PREVOST

WARRANTY BULLETIN

WB14-31

DATE :	JULY 2014	SECTION :	18 - Body
EXPIRATION:	JULY 2016		
SUBJECT :	CABLE PROTECTION IN FRONT FENDER

Figure 1

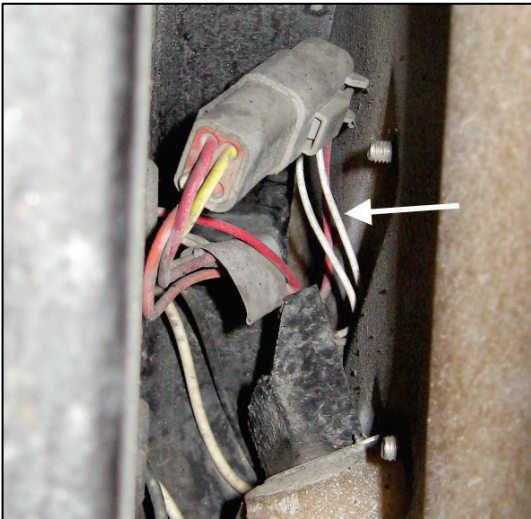
1. Looking in the gap between the fiberglass fender and the bus structure (Fig.1 & 2), perform a thorough inspection of the door switch wires between grommet and connector (Fig. 2 & 3) using a mirror to inspect all around wires.

Figure 2

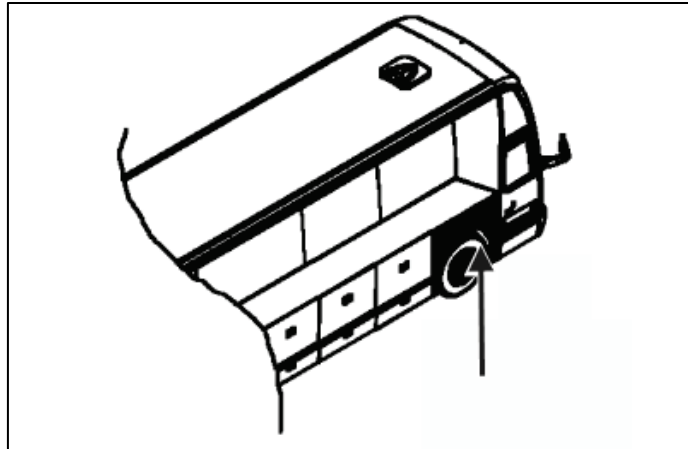
Check that the insulation material of the 3 wires is intact and in good condition. (Fig. 2, 3)

Figure 4

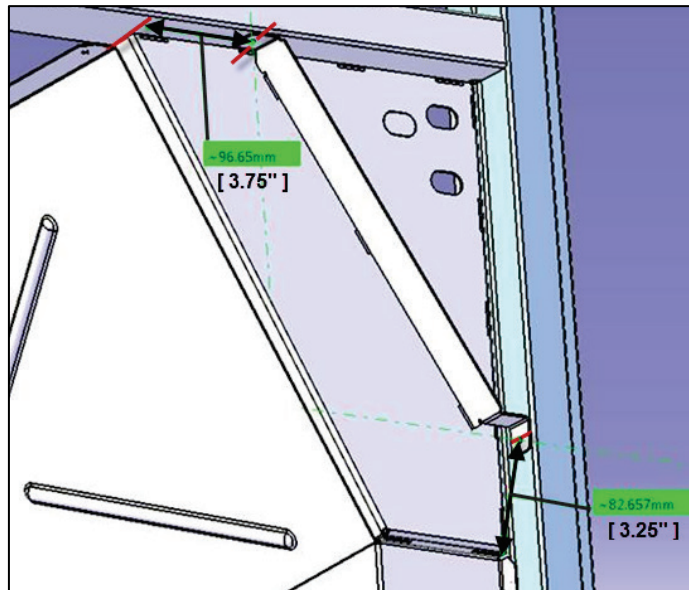
Add protector **#479423** and rubber trim **#479422** (12 3/8" long) (Fig. 4 & 5).

(Note protector orientation and suggested hole locations)

Drill 5/32" holes and Install with screw **#500623**.

Figure 13

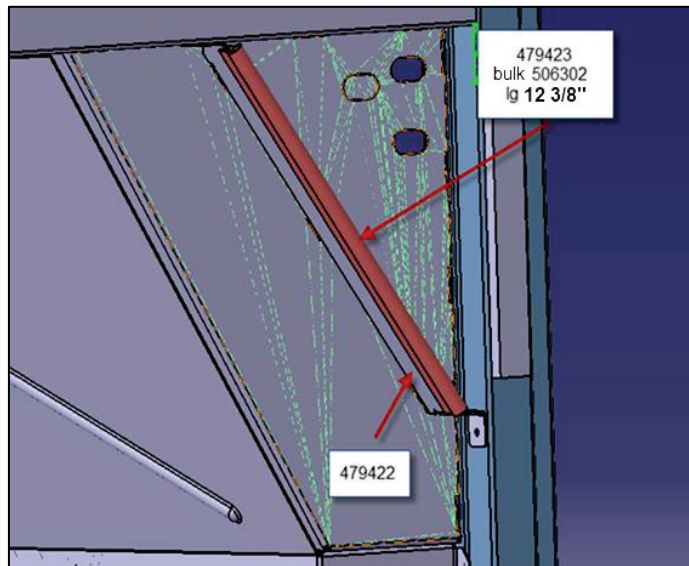
10. Add protector **#479423** and rubber trim **#479422** (12 3/8" long). (Fig. 13& 14)

Note protector orientation and hole locations

11. Mark hole locations using protector as a template, drill 5/32" holes and Install with screw **#500623**
